## Proposal for the 02 series of amendments to UN Regulation No. 135 (Pole side impact)

### Submitted by the Working Party on Passive Safety \*

The text reproduced below was adopted by the Working Party on Passive Safety Provisions (GRSP) at its seventieth session (ECE/TRANS/WP.29/GRSP/70, para. 23). It is based on ECE/TRANS/WP.29/GRSP/2021/21 not amended. It is submitted to the World Forum for Harmonization of Vehicle Regulations (WP.29) and to the Administrative Committee (AC.1) for consideration at their June 2022 sessions.

**"Annex 2**

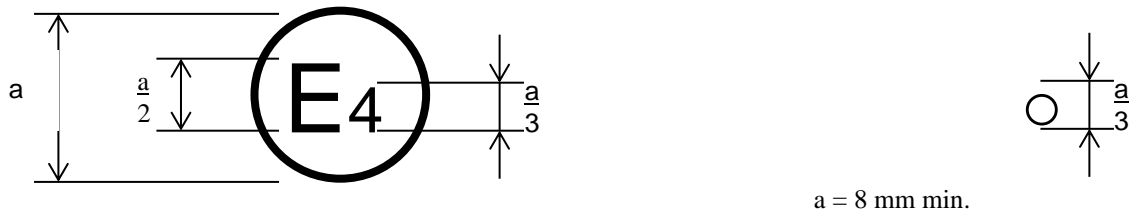
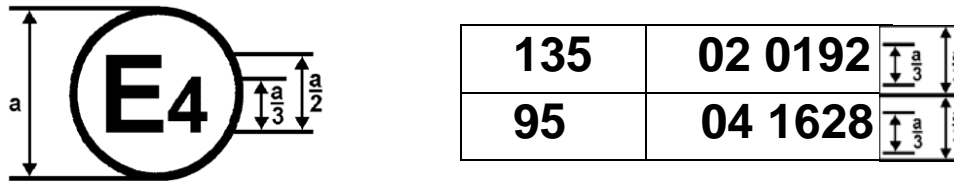
Annex 2, amend to read:

The above approval mark affixed to a vehicle shows that the vehicle type concerned has, with regard to its pole side impact performance, been approved in the Netherlands (E 4) pursuant to Regulation No. 135 under approval number 0124. The approval number indicates that the approval was granted in accordance with the requirements of Regulation No. 135 as amended by the 02 series of amendments.

The above approval mark affixed to a vehicle shows that the vehicle type concerned has been approved in the Netherlands (E 4) pursuant to Regulations Nos. 135 and 95.<sup>1</sup> The first two digits of the approval numbers indicate that, at the dates when the respective approvals were granted, Regulation No. 135 incorporated the 02 series of amendments and Regulation No. 95 incorporated the 04 series of amendments."

Figure 1  
Measurement of  $U_b$ ,  $U_1$ ,  $U_2$

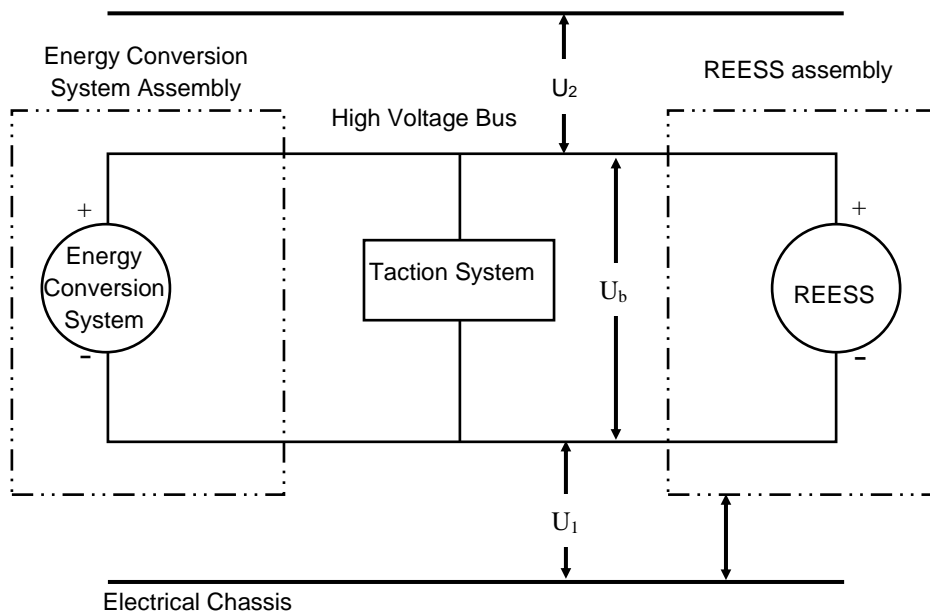
*Insert new Annex 11, to read:*

After the impact test, determine the high voltage bus voltages ( $U_b$ ,  $U_1$ ,  $U_2$ ) (see Figure 1 below).

Figure 2  
E.g. measurement of high voltage bus energy stored in X-capacitors

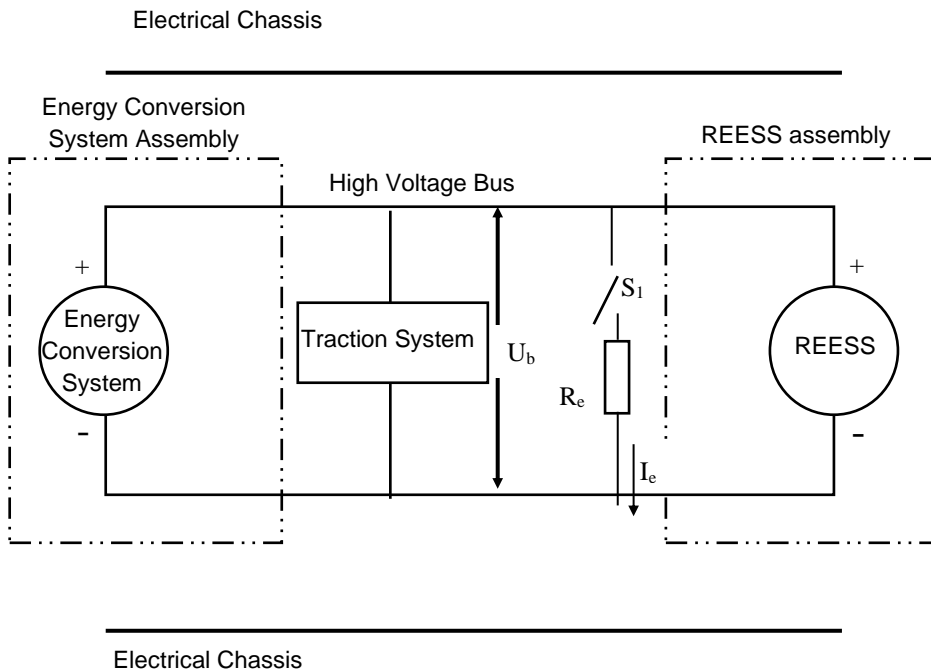
Prior to the impact a switch  $S_1$  and a known discharge resistor  $R_e$  is connected in parallel to the relevant capacitance (ref. Figure 2 below).

Figure 3  
**Jointed Test Finger**

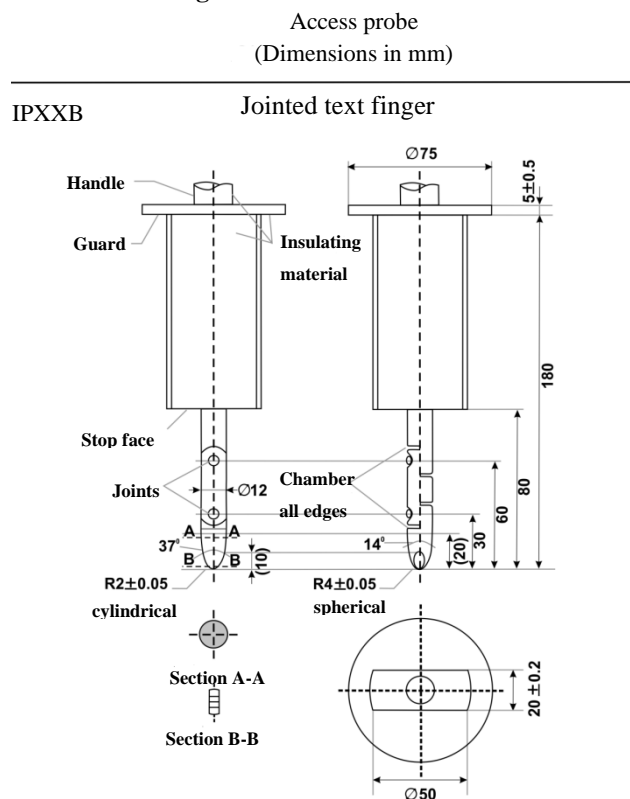
The jointed test finger described in Figure 3 shall be inserted into any gaps or openings of the physical protection with a test force of  $10\text{ N} \pm 10\text{ per cent}$  for electrical safety assessment. If partial or full penetration into the physical protection by the jointed test finger occurs, the jointed test finger shall be placed in every position as specified below.

Figure 4  
Example of the Test Method using DC Power Supply

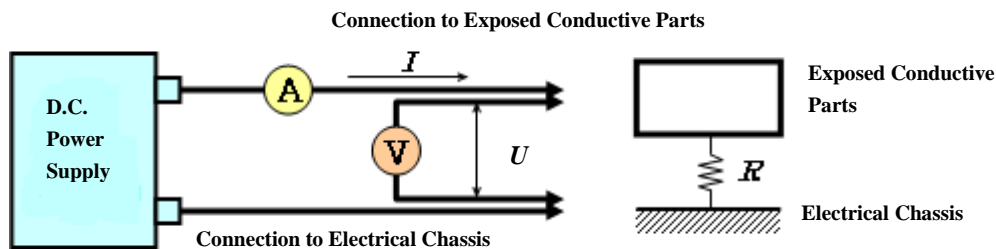
Example of the test method using DC power supply, voltmeter and ammeter is shown below.

Figure 5  
Measurement of  $U_1'$

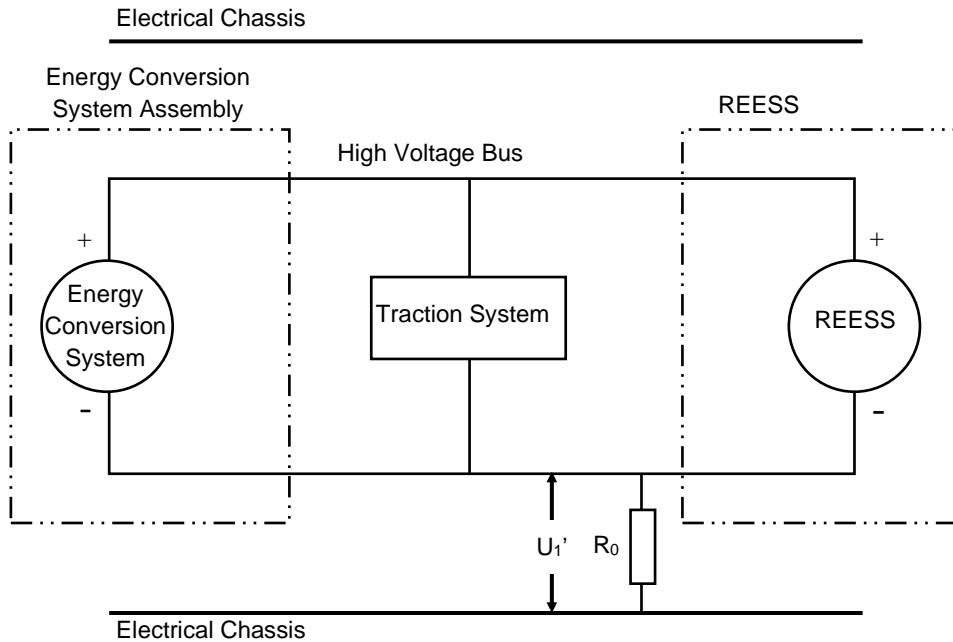
With  $R_o$  installed, the voltage ( $U_1'$ ) between the negative side of the high voltage bus and the electrical chassis is measured (see Figure 5).

Figure 6  
Measurement of  $U_2'$

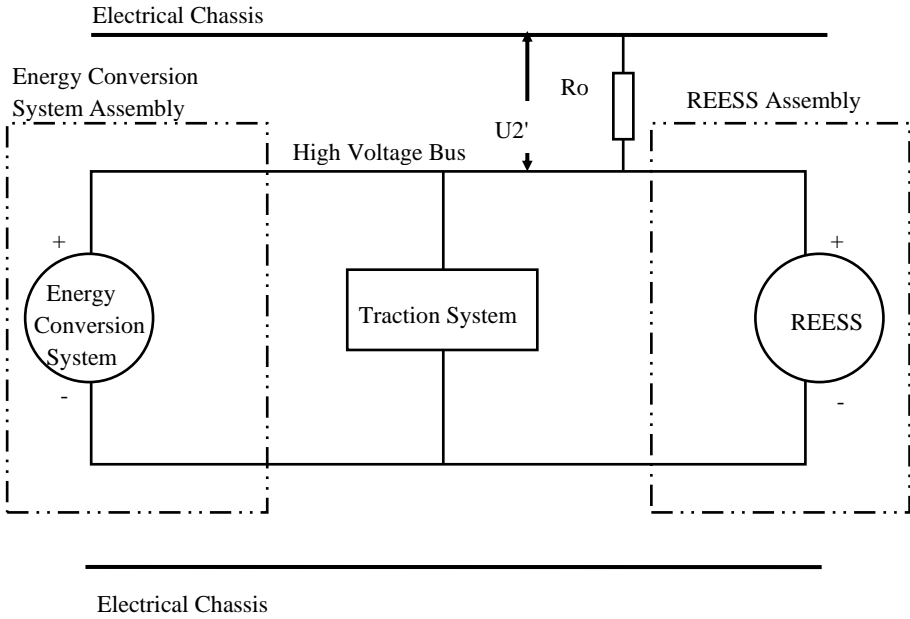
If  $U_2$  is greater than  $U_1$ , insert a standard known resistance ( $R_o$ ) between the positive side of the high voltage bus and the electrical chassis. With  $R_o$  installed, measure the voltage ( $U_2'$ ) between the positive side of the high voltage bus and the electrical chassis (see Figure 6 below). The electrical isolation ( $R_i$ ) is calculated according to the following formula:
